San Gabriel Valley Superfund Sites / Baldwin Park Operable Unit

U.S. Environmental Protection Agency • Region 9 • San Francisco, CA • May 1999

EPA Updates Cleanup Plan for the Azusa-Irwindale-Baldwin Park Area

Figure 3: Approximate extent of perchlorate, NDMA and 1,4-dioxane contamination in groundwater

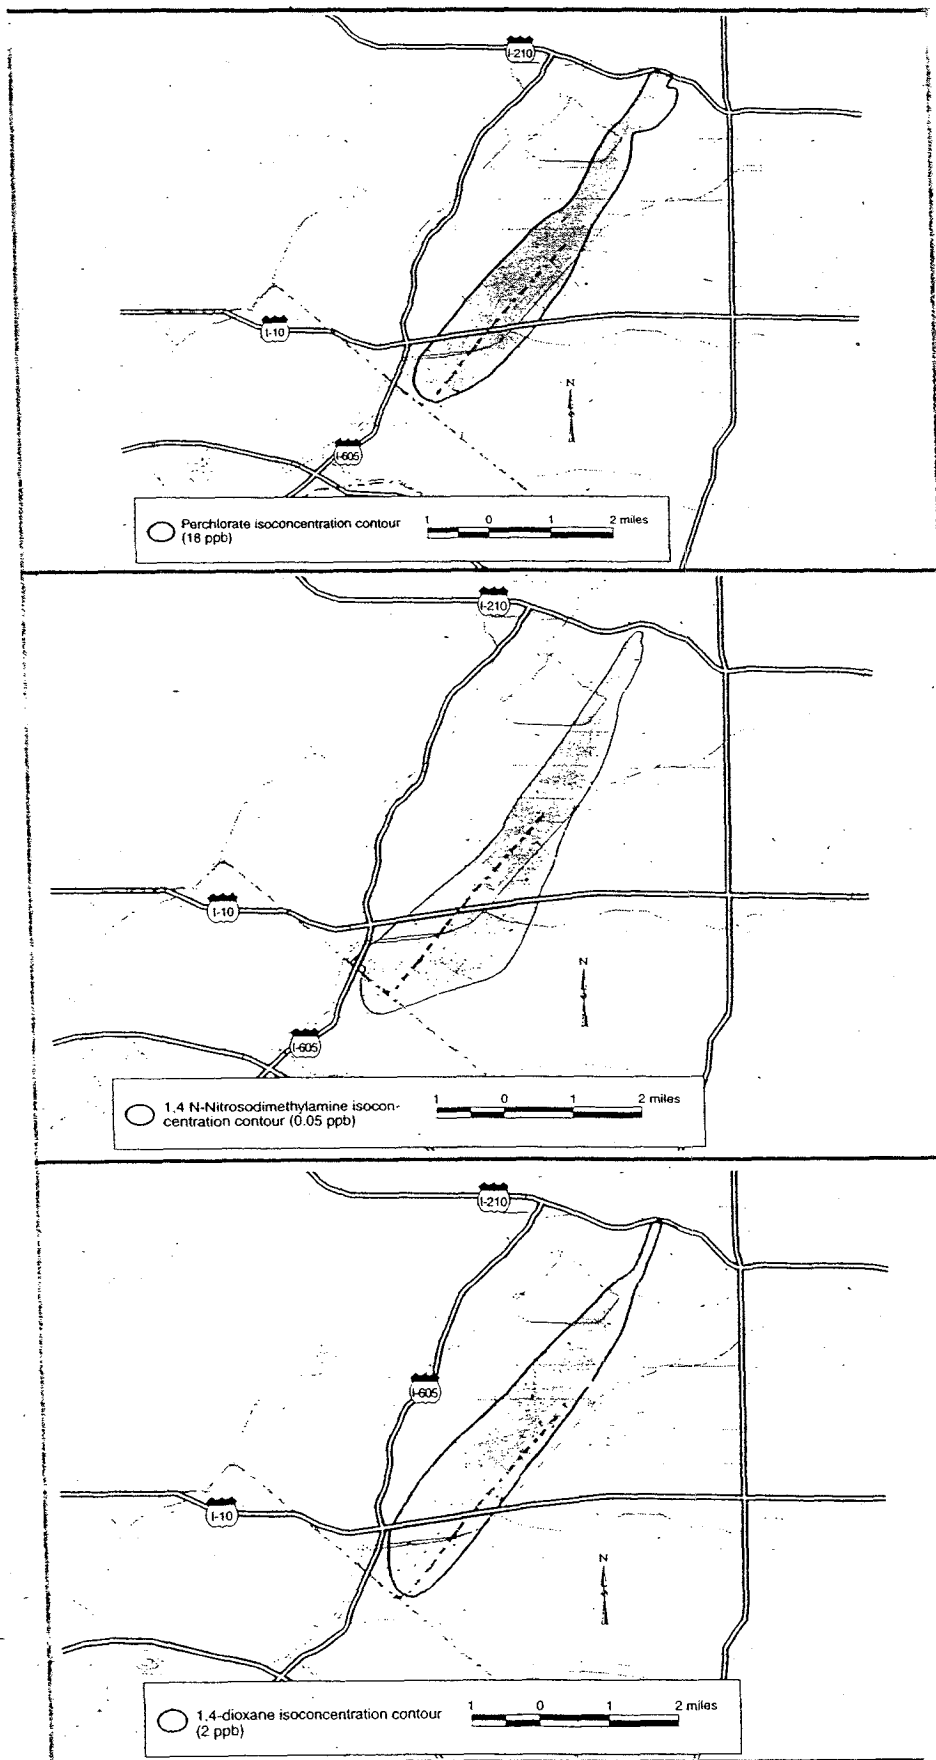
The highest concentrations of perchlorate, NDMA, and 1,4-dioxane are found in the groundwater in Azusa, in Subarea 1. Maximum concentrations of perchlorate and NDMA are more than 100 times the State drinking water action levels of 18 and 0.002 ppb respectively. The maximum concentration of 1,4-dioxane is more than 20 times the State drinking water action level of 3 ppb. Up to six miles downgradient of the industrial source area in Azusa, at the likely groundwater extraction locations in Subarea 3, perchlorate and NDMA concentrations remain above State action levels. The concentration of 1,4-dioxane in this area has, to date, been below the State action level. Figure 3 depicts the approximate extent of perchlorate, NDMA and 1,4-dioxane contamination in groundwater in the Baldwin Park OU.

Figure 4: Groundwater treatment technologies

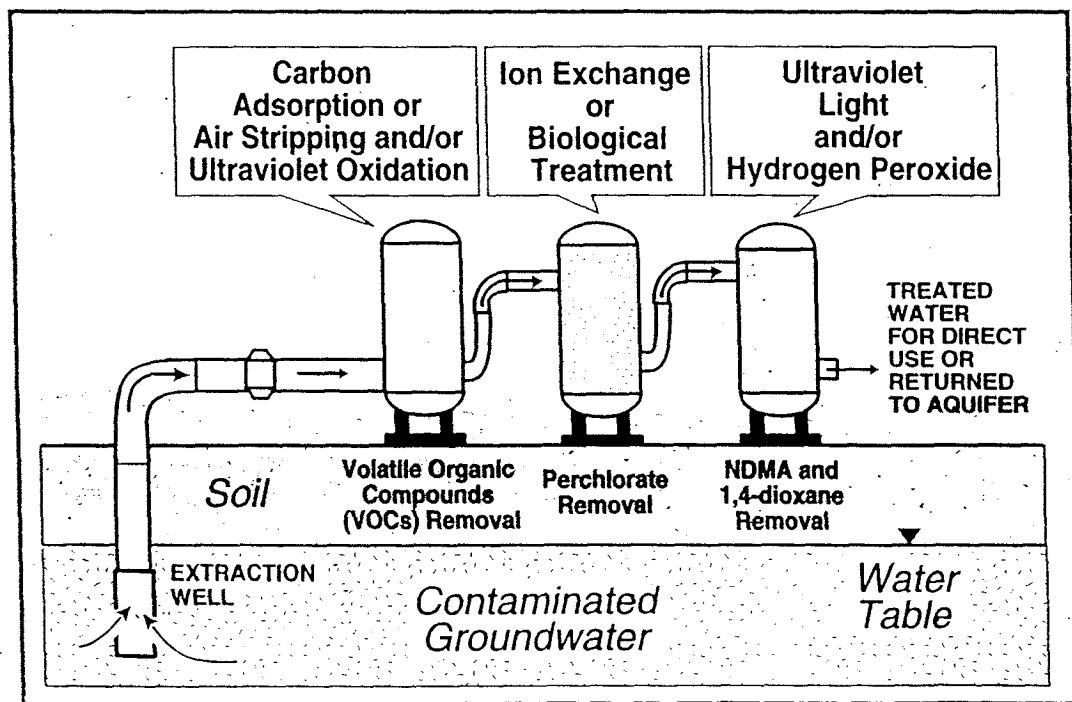
reactor, followed by a biologically-active multimedia filter and granular activated carbon (GAC) *polishing treatment* (see Figure 4). The system will also include ultraviolet light treatment for removal of NDMA and VOCs. Biological treatment methods are new to many water utilities, but *biologically active* filters have been used in drinking water treatment for decades to help remove particles and biodegradable organic matter.
